SEWAGE DISPOSAL SYSTEM

MARYLAND STATE DEPARTMENT OF HEALTH

HOWARD COUNTY

LOCATION SURVEY

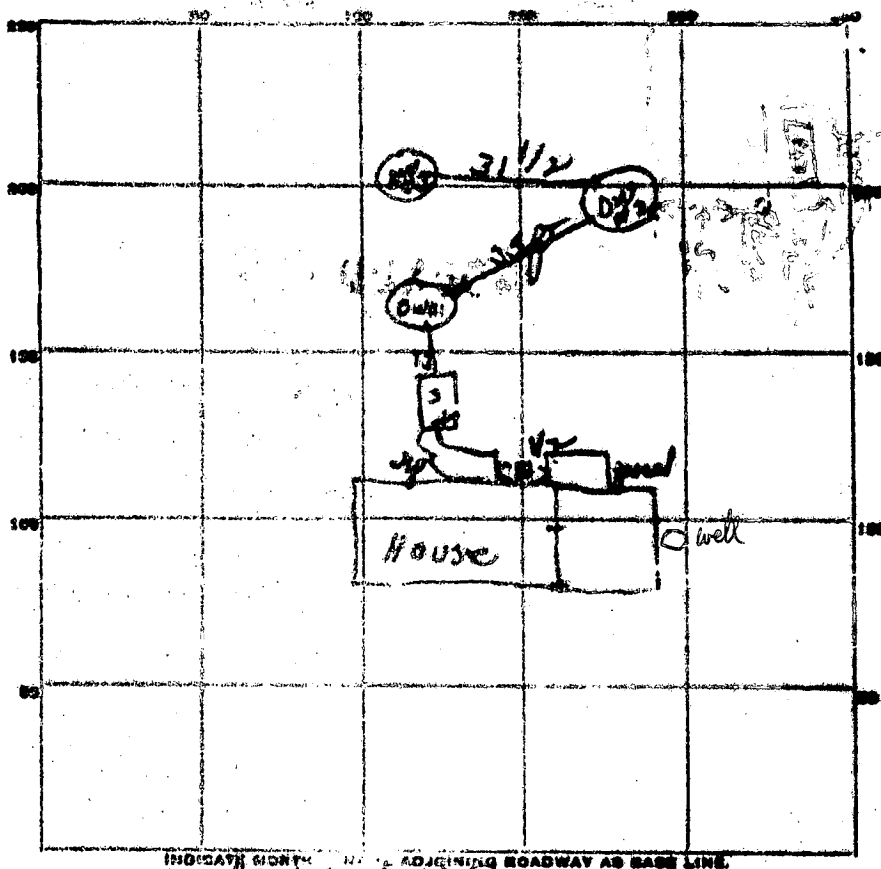
OTHER 10 Dry wells - 2 Dry wells - each 24 in. diameter and 3 ft. deep below

inlet pipe. Inlet pipe no deeper than 4 ft. below grade. first 2 chambers

120 ft. from left side line or deep when facing from Ed Marple Rd with one

dry well 200 ft. from front lot line and other dry well 200 ft. from front lot line

about 15 ft. from front lot line and about 35 ft. from front lot line.

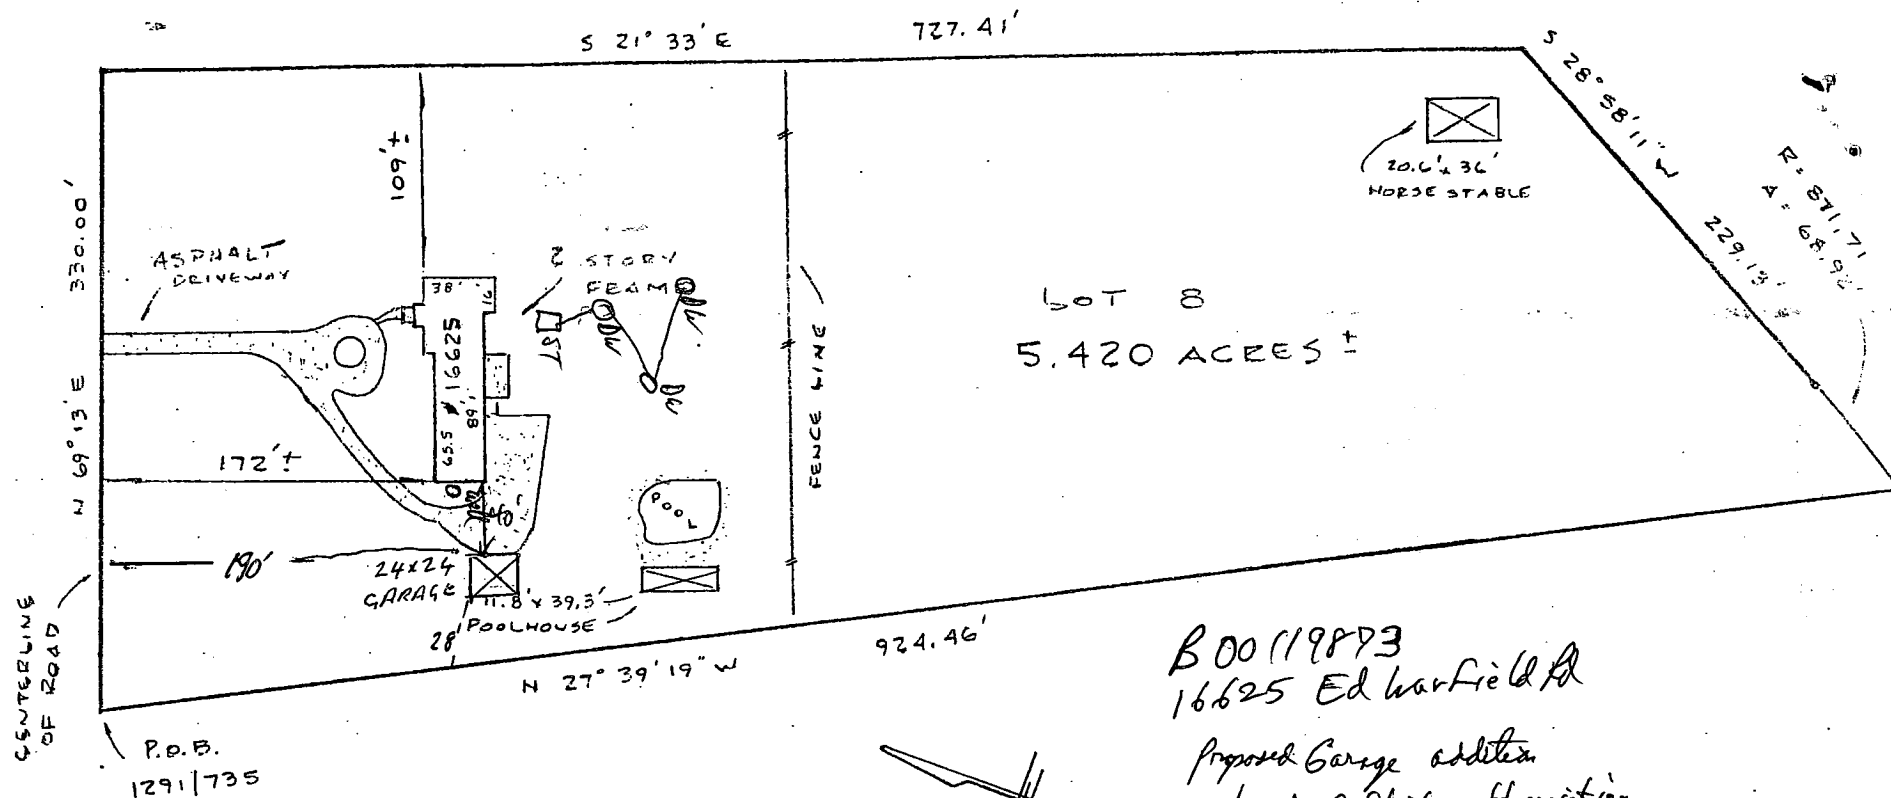
REMARKS 3/6/68
Dry Well #1 11 ft well to well diameter and 9 ft pipe inlet =
" " #2 10 1/2 " " " " " 9 ft " " "
" " #3 11 " " " " " 9 ft " " "

Total 27 ft

line from house to Septic Tank not yet installed - believe final inspection
when done - OK to come from Septic Tank to including dry wells
